Access Compliance Report

Public Rights-of-Way

(Curb Ramps)

Intersection ID: 28627	Main Street: HAWKBILL_PL	Cross Street: STUARTS_DRAFT_CT	Location: SE
ADA ID: 5CA44D762235	Ramp Type: PerpDiag	Initial Pass/Fail: Fail	Overall Compliance: No
Severity Score: 13.75			
Codes/Mitigation Info/Possible Solution		Field Measurements/Component Compliance

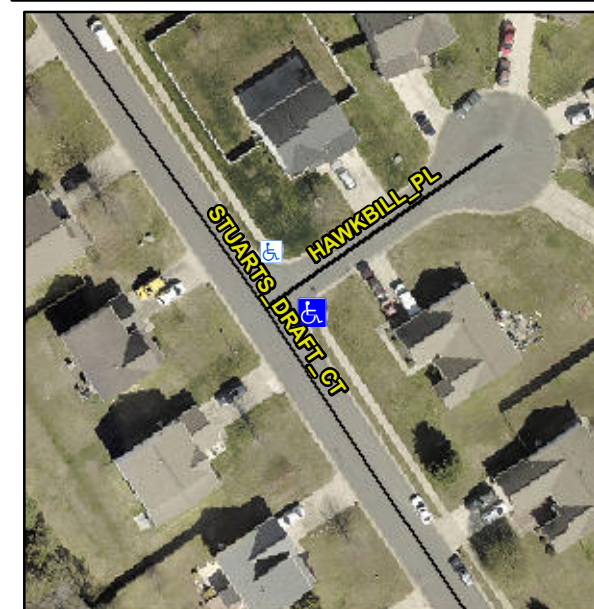
R304.2.2, R304.5.3

Compliance	Description	Data	Compliance	Description	Data
N/A	Ramp Length (in)	48.5	No	Ramp Slope (%)	8.7
Yes	Ramp Width (in)	48.0	No	Ramp XSlope (%)	4.8
N/A	Flare Type LT	N/A	N/A	Flare Type RT	N/A
N/A	Flare Slope LT (%)	N/A	N/A	Flare Slope RT (%)	N/A
N/A	Flare Traversable LT?	N/A	N/A	Flare Traversable RT?	N/A
N/A	Landing Length (in)	N/A	N/A	DWS Provided?	N/A
N/A	Landing Width (in)	N/A	N/A	DWS Contrast?	N/A
N/A	Landing Slope (%)	N/A	N/A	DWS Length (in)	N/A
N/A	Landing X Slope (%)	N/A	N/A	DWS Full Width?	N/A
N/A	Landing Curb? (Y/N)	N/A	N/A	DWS Offset (in)	N/A
N/A	Shared Landing?	N/A			
N/A	Gutter Ponding?	N/A	N/A	Gutter Slope (%)	N/A
N/A	Gutter Lip Ht (in)	N/A	N/A	Gutter X Slope (%)	N/A
N/A	Painted X Walk1?	No	N/A	Painted X Walk2?	No
	X Walk 1 Direction	To NW		X Walk 2 Direction	To SW
N/A	X Walk 1 Width (in)	N/A	N/A	X Walk 2 Width (in)	N/A
	X Walk 1 Slope (%)	4.9		X Walk 2 Slope (%)	9.0
	X Walk 1 X Slope (%)	0.8		X Walk 2 X Slope (%)	0.4

N/A	Ramp inside XWalk1?	N/A	N/A	Ramp inside XWalk2?	N/A
	Road Slope (%)	3.4	N/A	Clear Space?	N/A
	Road X Slope (%)	7.9	N/A	Clear Space to XWalk (in)	N/A
N/A	Any Obstructions?	N/A	N/A	Storm Grate/Utility Hazard?	N/A
	Obstruction Type			Storm Grate/Utility Type	
		N/A			N/A
		Yes		Surface Condition? (G/P)	Good

Remove & Replace Curb Ramp With Two New Directional Ramps or Equivalent.
